NINE MILE POINT NUCLEAR STATION, UNIT NO. 1

AMENDMENT TO FACILITY OPERATING LICENSE

Amendment No. 47
License No. DPR-63

SAFETY EVALUATION BY THE OFFICE OF NUCLEAR REACTOR REGULATION
SUPPORTING AMENDMENT NO.47 TO FACILITY OPERATING LICENSE NO. DPR-63

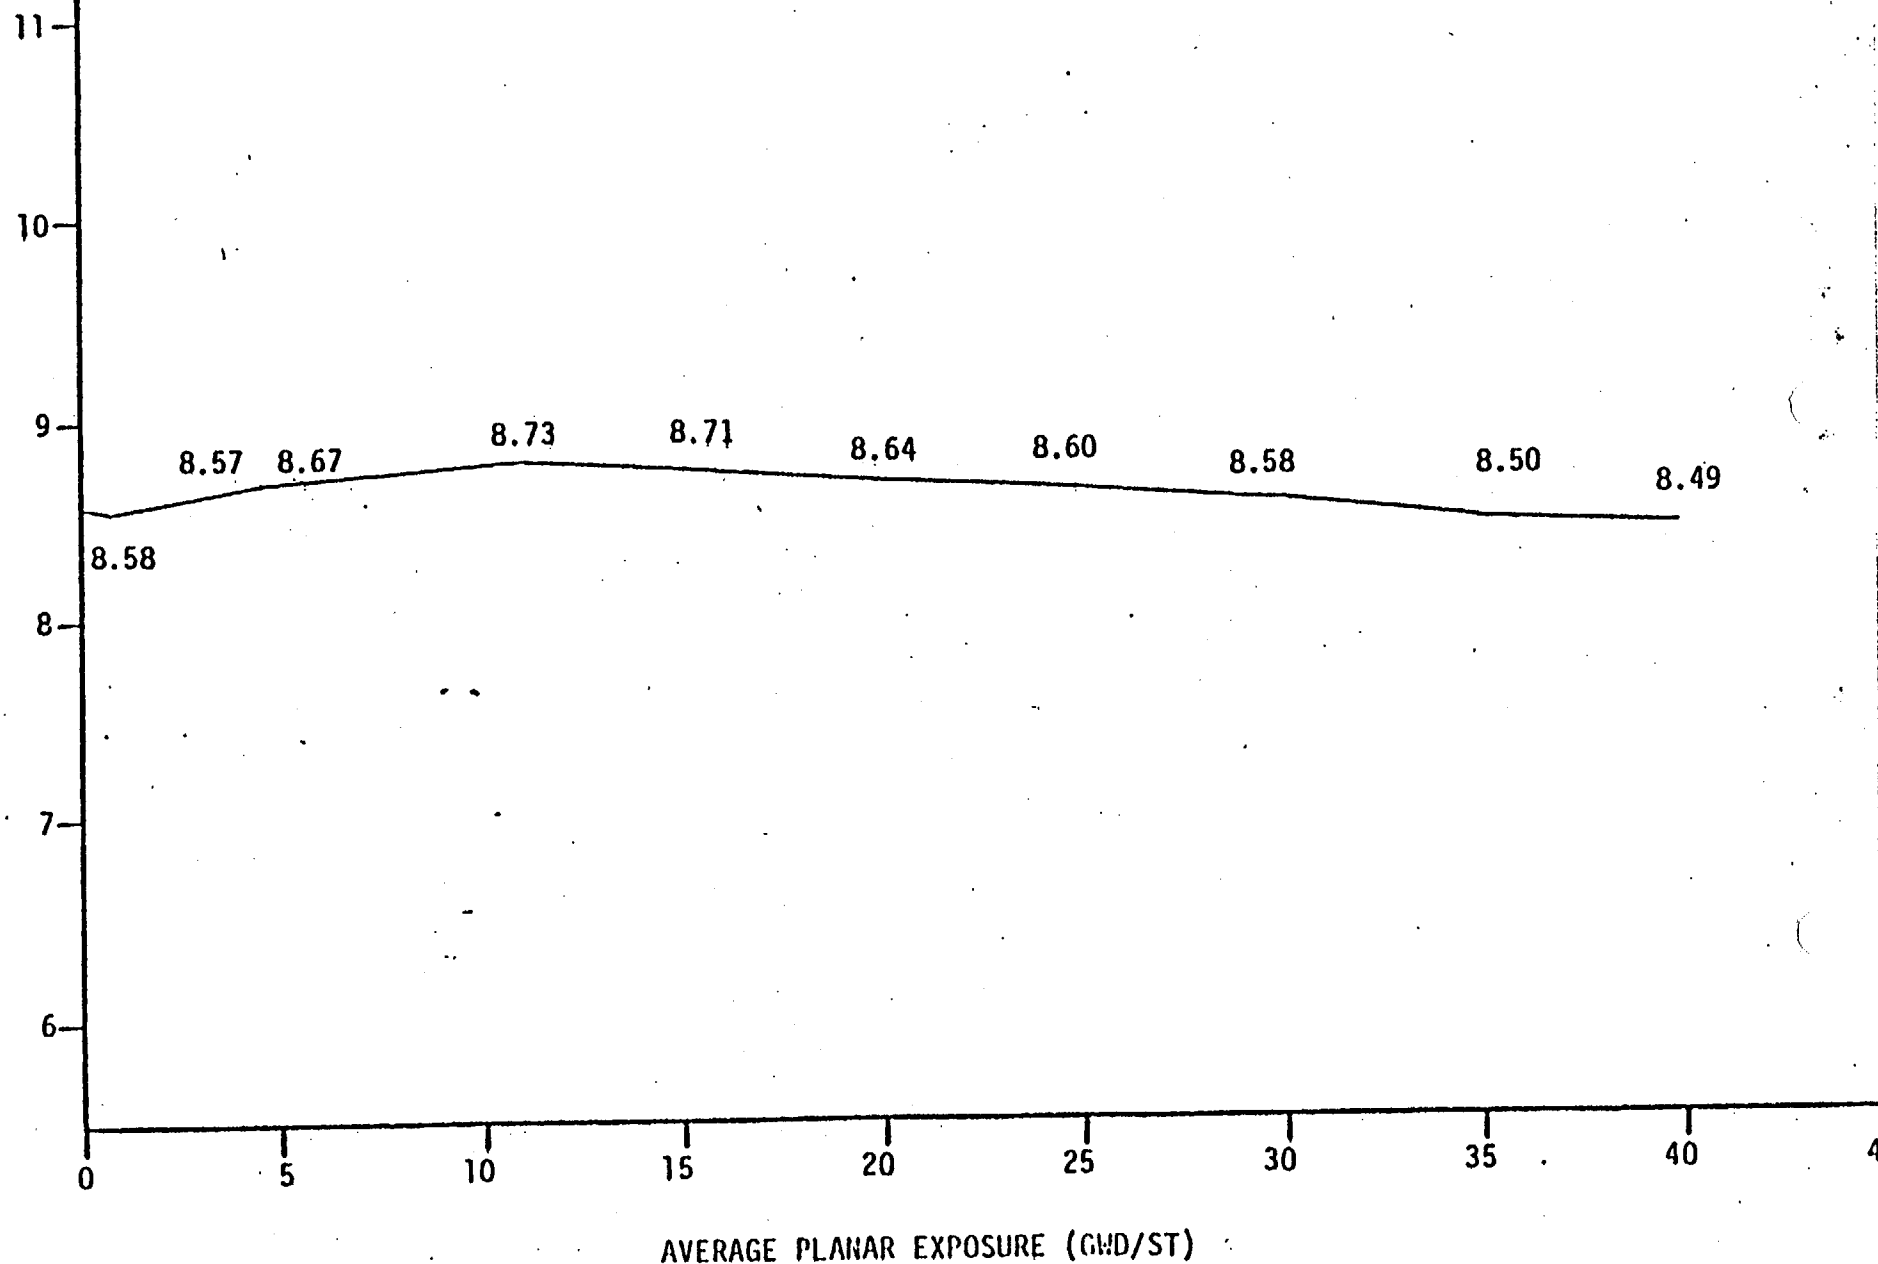
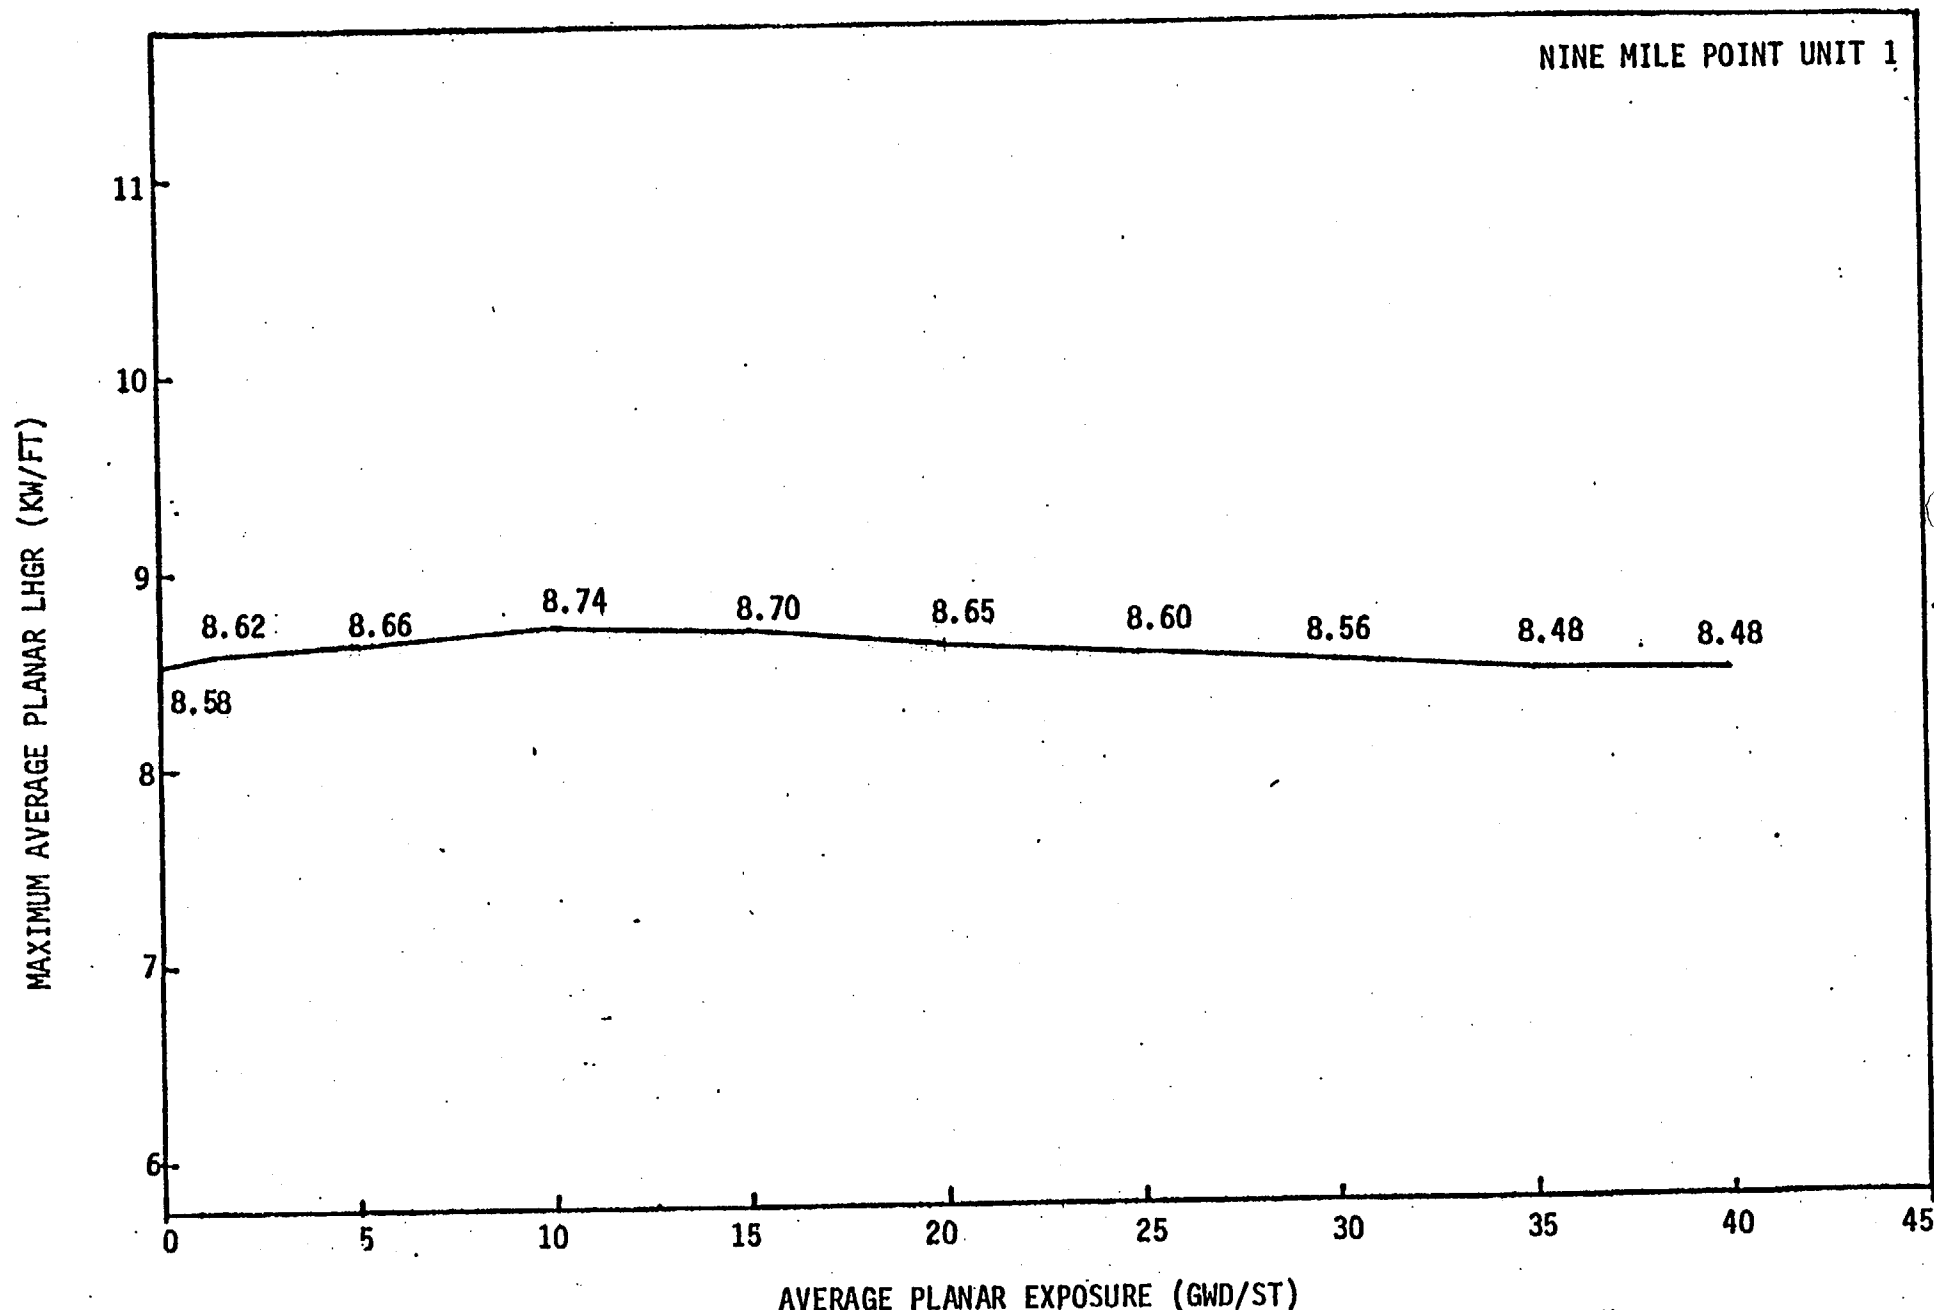
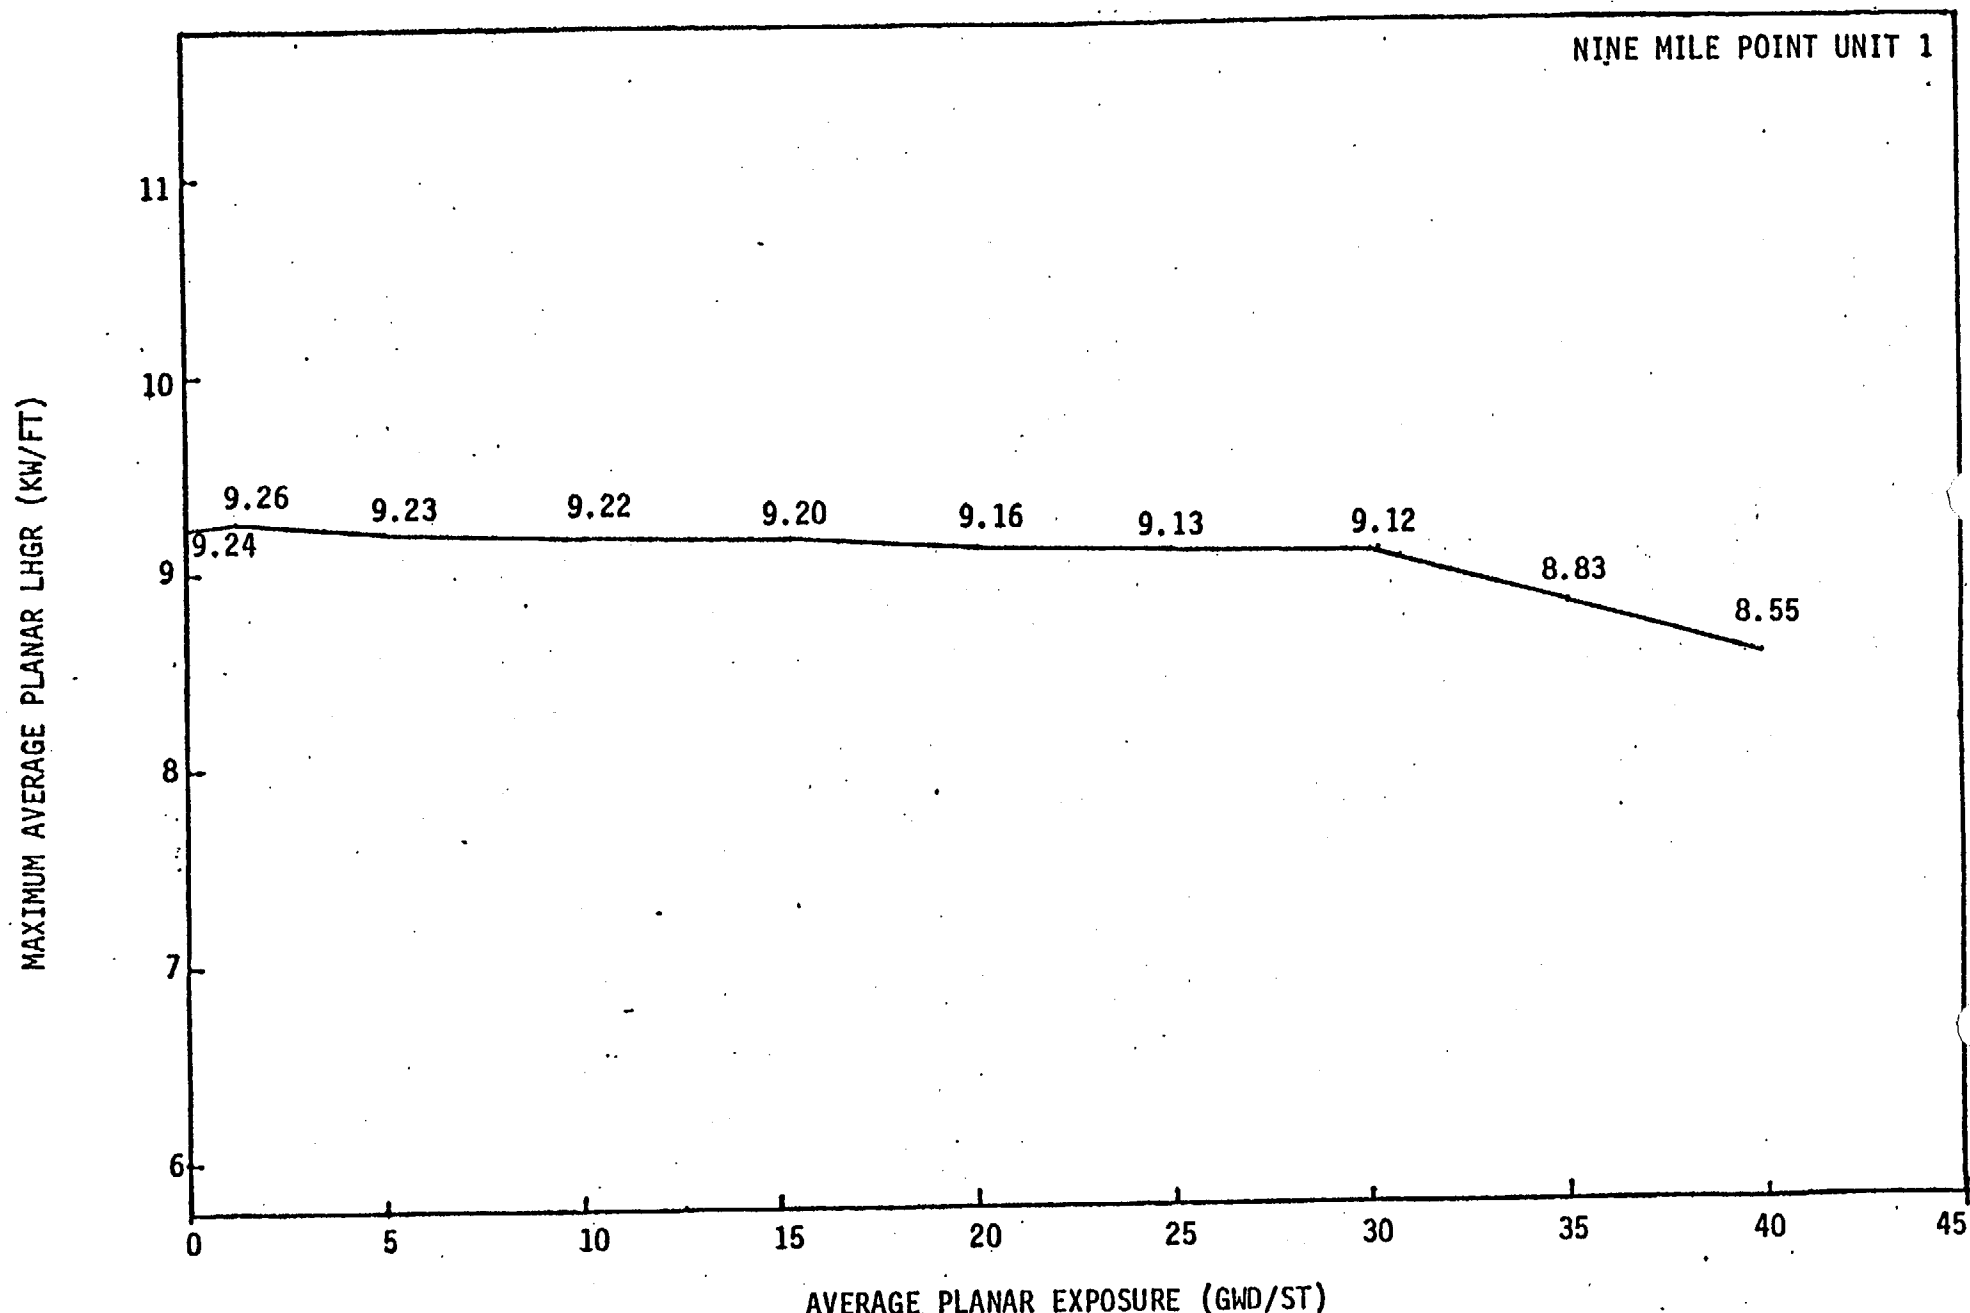
The Commission has issued the enclosed Amendment No. 47 to Facility Operating License No. DPR-63 for the Nine Mile Point Nuclear Station Unit No. 1. The amendment is in response to your request dated October 26, 1981 and it revises Maximum Average Planar Linear Heat Generation Rate (MAPLHGR) Technical Specifications.

The amendment revises the Technical Specifications to modify the Maximum Average Planar Linear Heat Generation Rate.

When operating with four recirculation loops in operation and the remaining loop unisolated, the reactor may operate at 100 percent of full licensed power level in accordance with Figure 3.1.7aa and an APLHGR not to exceed 98 percent of the limiting values shown in Figures 3.1.7a, 3.1.7b, 3.1.7c, 3.1.7d, and 3.1.7e.

When operating with four recirculation loops in operation and one loop isolated, the reactor may operate at 100 percent of full licensed power in accordance with Figure 3.1.7aa and an APLHGR not to exceed 98 percent of the limiting values shown in Figures 3.1.7a, 3.1.7b, 3.1.7c, 3.1.7d, and 3.1.7e, provided the following conditions are met for the isolated loop.

When operating with three recirculation loops in operation and the two remaining loops isolated or unisolated, the reactor may operate at 90 percent of full licensed power in accordance with Figure 3.1.7aa and an APLHGR not to exceed 96 percent of the limiting values shown in Figures 3.1.7a, 3.1.7b, 3.1.7c, 3.1.7d, and 3.1.7e.
